TENNESSEE VALLEY AUTHORITY

SEQUOYAH NUCLEAR PLANT - NPDES PERMIT NO. TN0026450 - NOTIFICATION OF
CHANGE IN OUTFALL LOCATION 54-327 54-328

SEQUOYAH NUCLEAR PLANT
NPDES SERIALIZED
DISCHARGE LOCATIONS

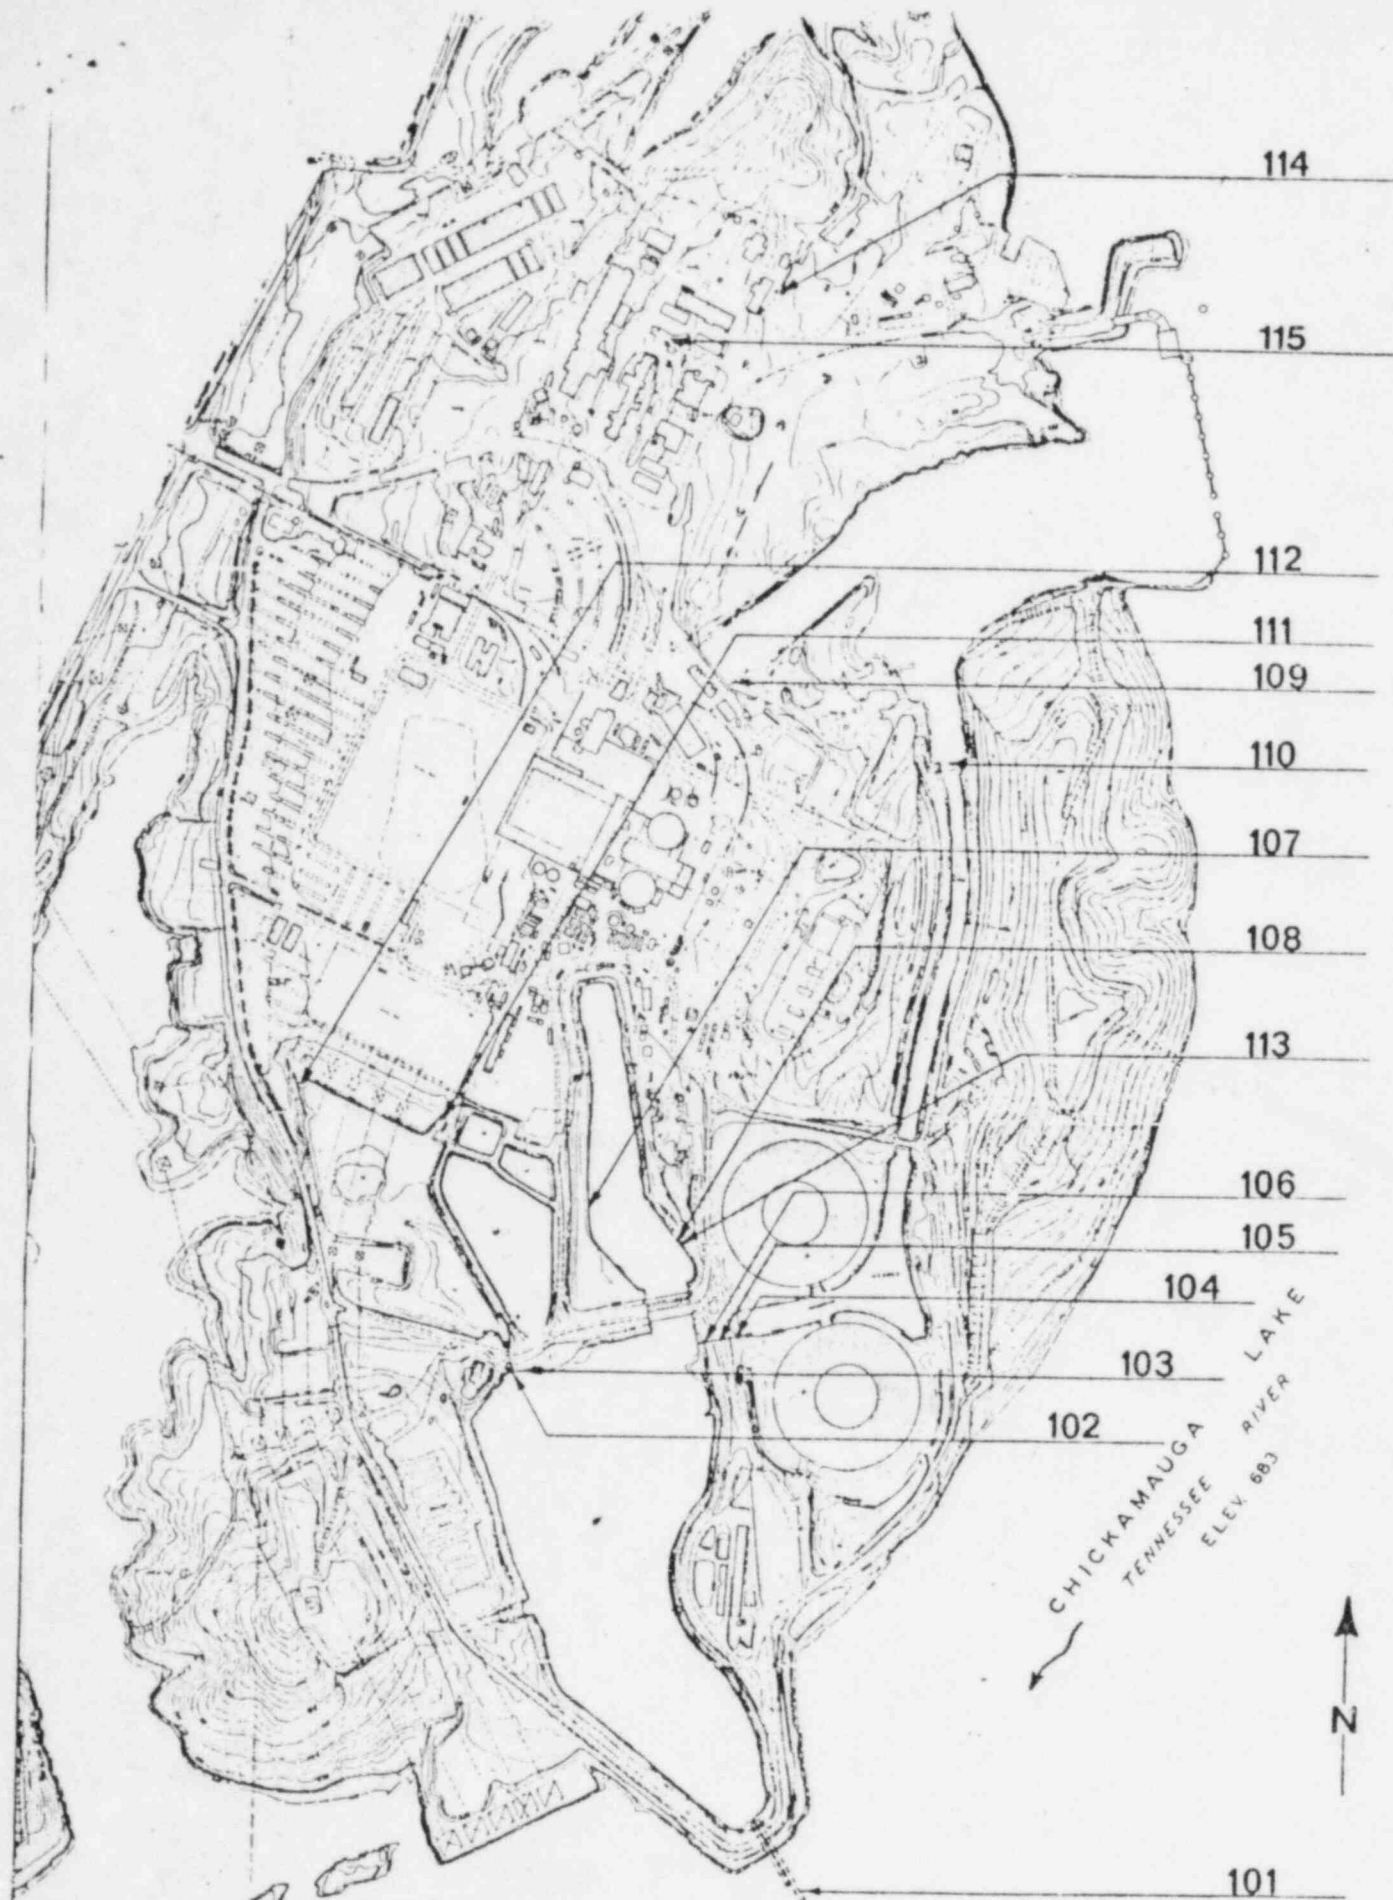
In accordance with Part II, Section D.1, of the NPDES permit, this is to notify you of a change in the discharge location for outfall serial No. (DSN) 112, sewage treatment plant effluent. Construction of the septic tank-sand filter system was completed in late summer 1983. The original outfall location was identified as the plant intake basin; however, a design change will route the system's effluent to the yard drainage pond, DSN 102. Enclosed is a revised flow diagram illustrating this change.

The yard drainage pond presently receives the effluent from our operational septic tank-sand filter, DSN 111, and has an average flow (September 1979 to May 1982) of 4.32 MGD. Because this pond presently receives sewage treatment plant effluent and the flow from DSN 112 (0.025 MGD) represents only 0.6-percent increase in the pond's total effluent flow, we do not believe an increase in effluent monitoring requirements for DSNs 112 and 102 is warranted.

The State of Tennessee certification for NPDES permit No. TN0026450 requires effluent monitoring for settleable solids from DSN 112 but not for DSN 111. Both wastewater treatment facilities are septic tank-sand filter systems, which typically do not have significant settleable solids in their discharges. We believe the monitoring requirements should be the same for both effluents because they are similar in character and have the same outfall location. By copy of this letter, we request the State to modify its certification by deleting the limitation and monitoring requirements for settleable solids on DSN 112.
